Ameren Services

September 12, 2013

Subject: Comments on "10 CSR 20-7.031 Water Quality Standards" Proposed Amendment, Published in the Missouri Register June 17, 2013"

Newly proposed streams within the LR

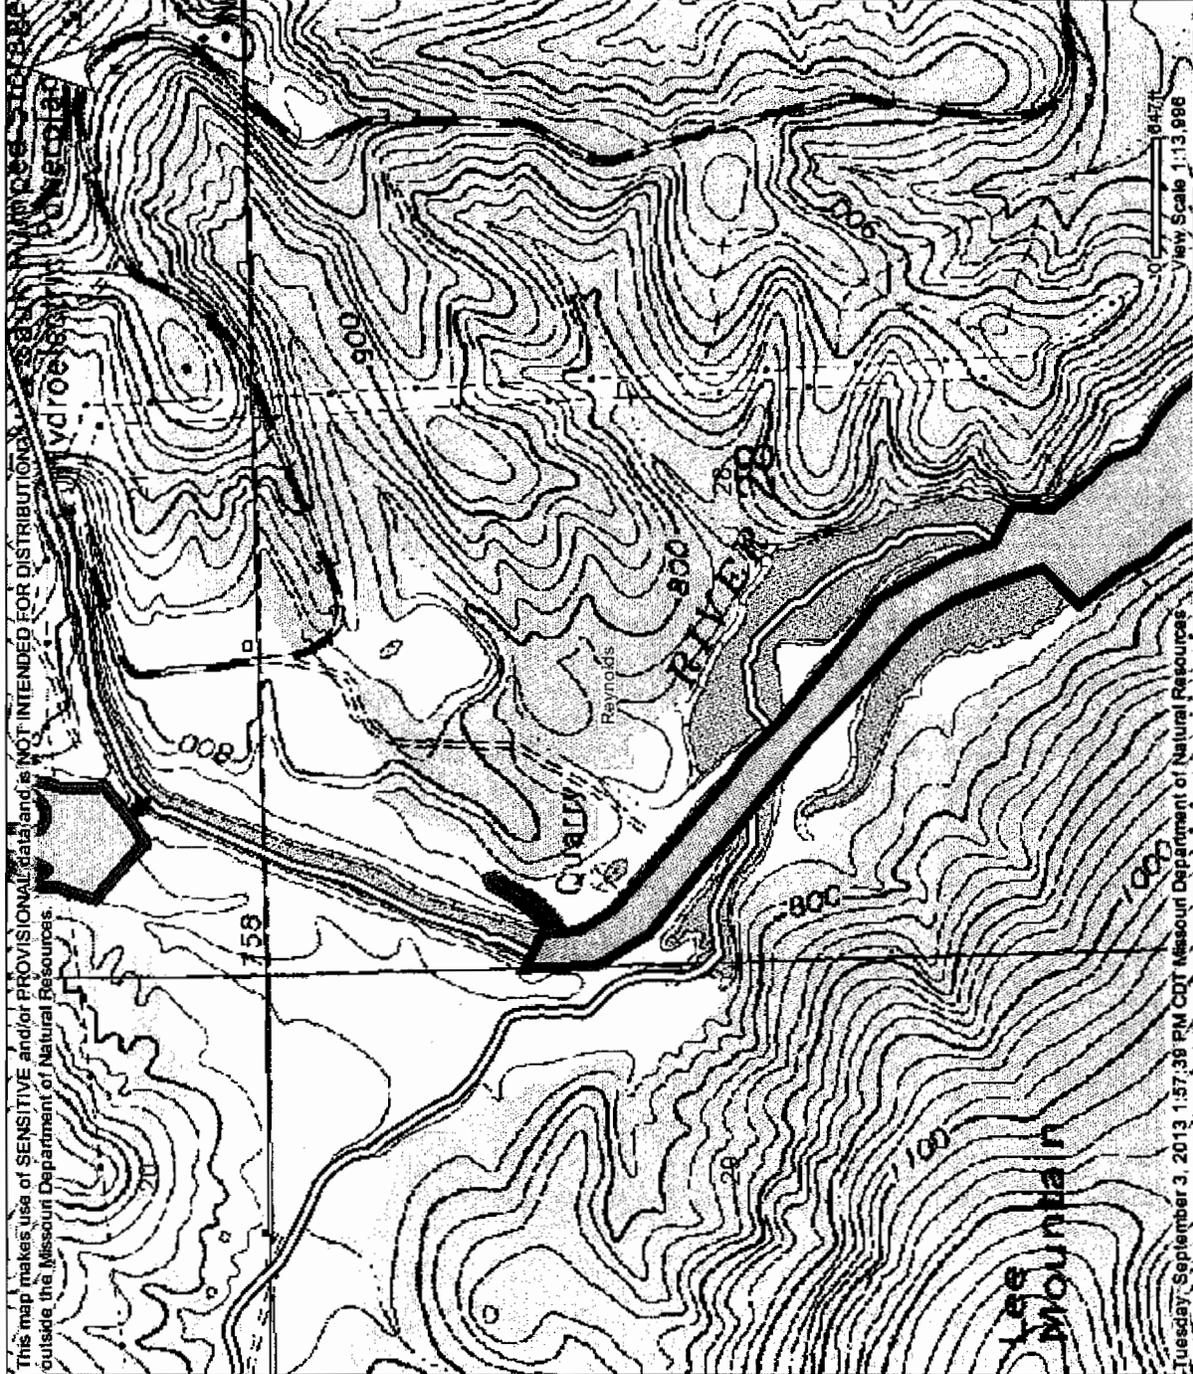
5. (& 6) Two proposed stream segments are located within, i.e. beneath the surface of the Lower Reservoir. While the resolution within the Map Viewer makes it unclear, this may be due to an errant decision as to how to depict the surface area of the Lower Reservoir. As stated above, the surface elevation of the Lower Reservoir fluctuates significantly, by approximately 12 feet (sometimes twice daily), resulting in significant changes to the area encompassed by this lake. The operating range is from an elevation of approximately 438.5 to 449.5 feet. Drainage from a proposed stream segment to the northeast flows into the Lower Reservoir although the lower portion is clearly within the Reservoir pool. Likewise, a proposed small stream segment to the east of the currently classified northern arm of the Lower Reservoir is within the pool. We believe that the portions of either proposed stream, lying beneath the 449.5 elevation, should be deleted. In conjunction with this change, the boundaries of the currently lake classification of Lower Reservoir should be expanded to this same, full pool elevation. For reference, the UTM coordinates for the two affected proposed stream segments are: Easting 691214, Northing 4153619 and Easting 6990612, Northing 4153784, respectively as described above.

Sioux Plant Site

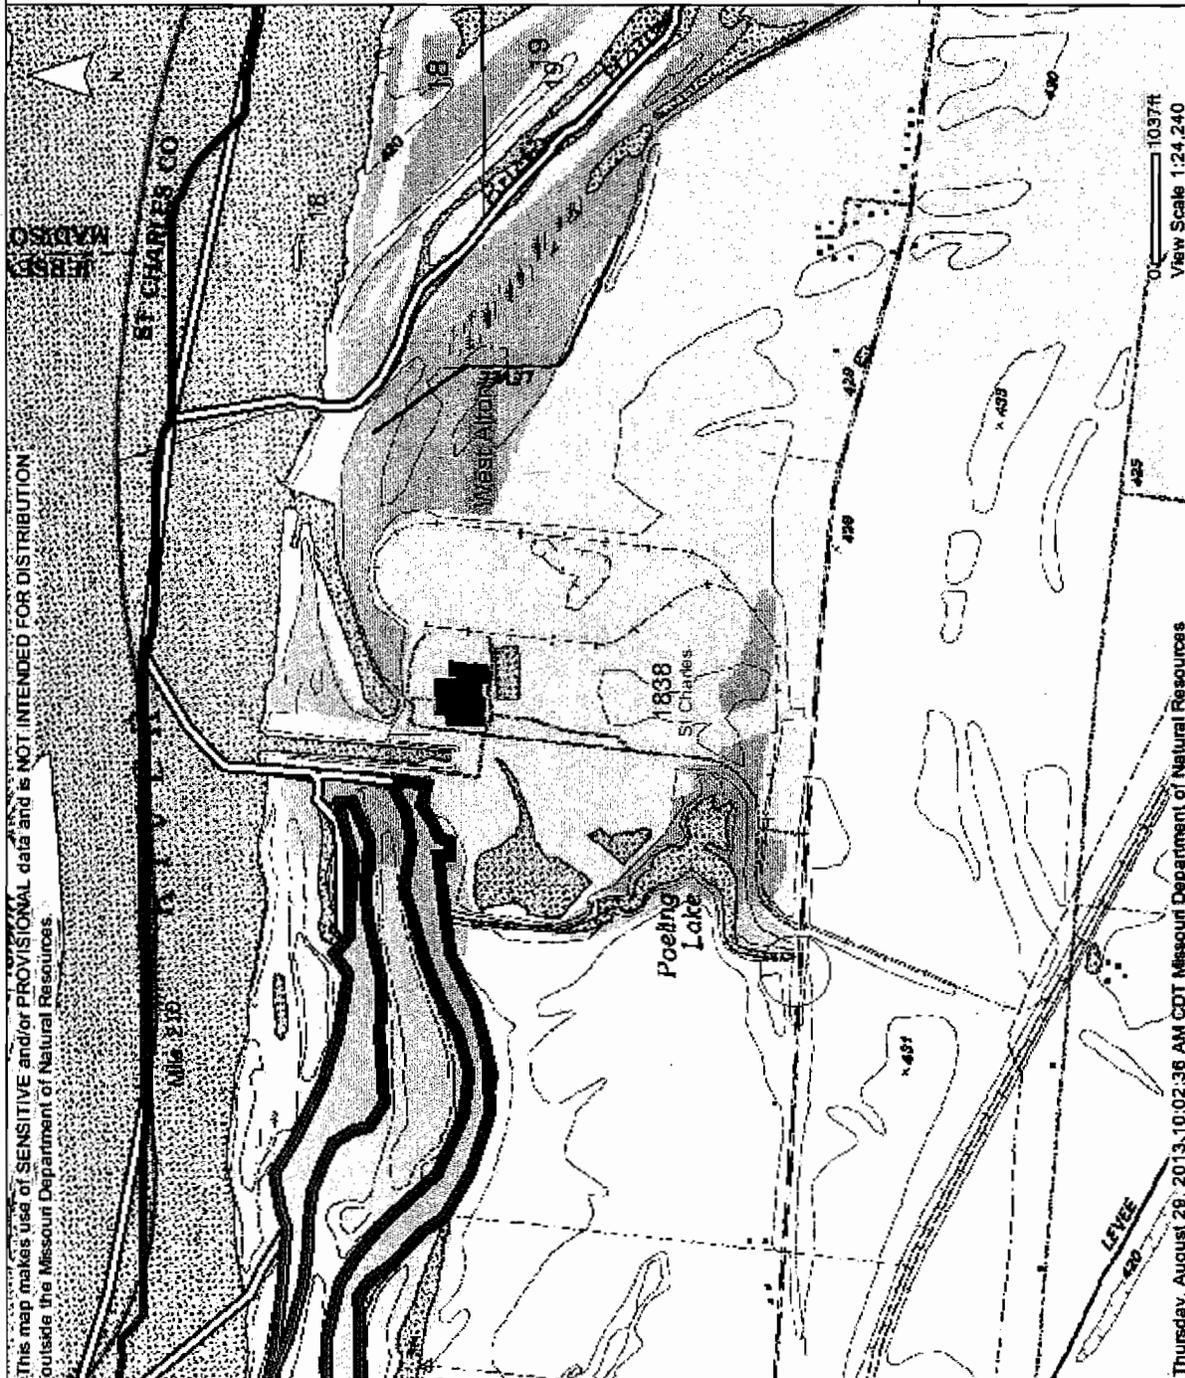
There are two proposed lakes adjacent to and northwest of the Sioux Energy Center, that appear to be backwater pools or sloughs within the ordinary high water mark of the Mississippi River. Releases from existing Outfalls 002 and 006 flow adjacent or through these areas prior to reaching the flowing stream. Creation of new classified lakes at these locations would be wholly inconsistent with their interaction with the Mississippi River. We believe the Department should delete these proposed designations. The approximate UTM coordinates are:

1. The northernmost 'backwater pool' – Easting 733819, Northing 4311182
2. The southernmost 'backwater pool' – Easting 733819, Northing 4310829
